# Access Compliance Report Public Rights-of-Way (Curb Ramps)

Main Street: ST\_BRIDE\_WAY Cross Street: ST\_STEVEN\_CT Location: NW

ADA ID: RPRK211110133409 Ramp Type: Type 4 - Parallel Initial Pass/Fail: Pass Overall Compliance: No Severity Score: 25

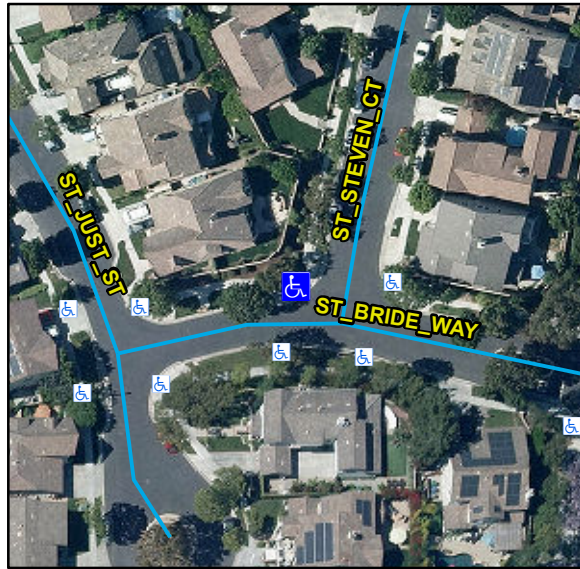
R204.3, R304.2.1, R304.2.2-Perp, R304.3.2-Para, R304.5.3, R305, R304.5.4, STD 1115

Remove & Replace Curb Ramp With Two New Directional Ramps or Equivalent. Remove & Replace Gutter.
